TECHNICAL INFORMATION

MODEL Range Rover 4.0/4.6	SUBJECT PRIDE - CHMSL Wiring Harness Repositioning	05/30/97 86/11/97/NAS
	AFFECTED VEHICLES LP 1995 up to TA334213 LH LJ LD

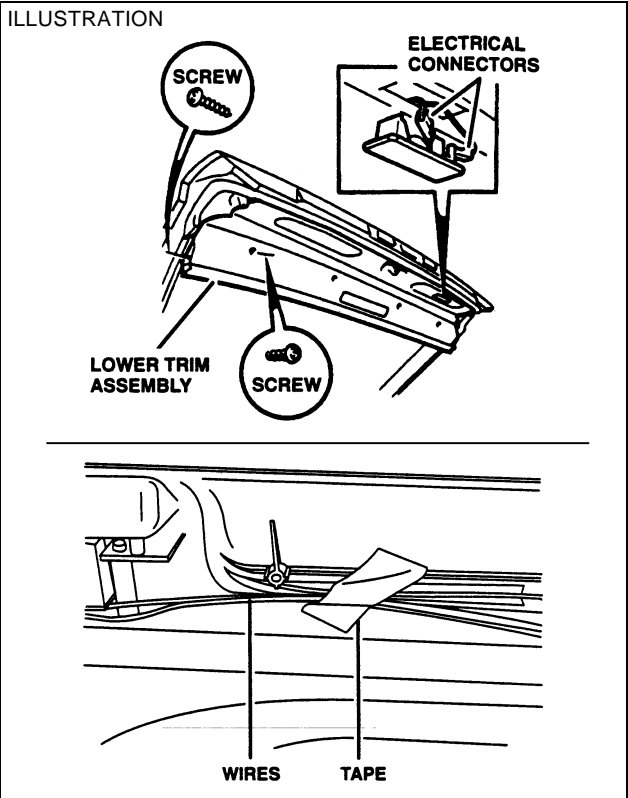
DETAIL
The wiring for the Center High Mount Stop Light (CHMSL) in the upper tailgate harness may be pinched by one of the screws that secures the panel shelf extension to the vehicle body. When this happens, the CHMSL shorts and blows Fuse 17. This results in a disabled shift interlock system and a vehicle that is stuck in PARK. Taping the CHMSL wires inside the trim piece away from the screw will prevent this from happening.

1. Disconnect the negative battery terminal.
2. Open upper tailgate.
3. Release load space lamp from the trim panel, disconnect the electrical connectors and remove the lamp.
4. Remove six Phillips screws securing the trim panel to the upper tailgate (illustration).
5. Release the 4 studs securing the trim panel to the upper tailgate.
6. Disconnect the stop lamp connector.
7. Remove trim piece.
8. Inspect the wires and repair if necessary

Cut an approximately two inch by one inch wide piece of masking tape and secure the wires away from the screw post as shown in the illustration.
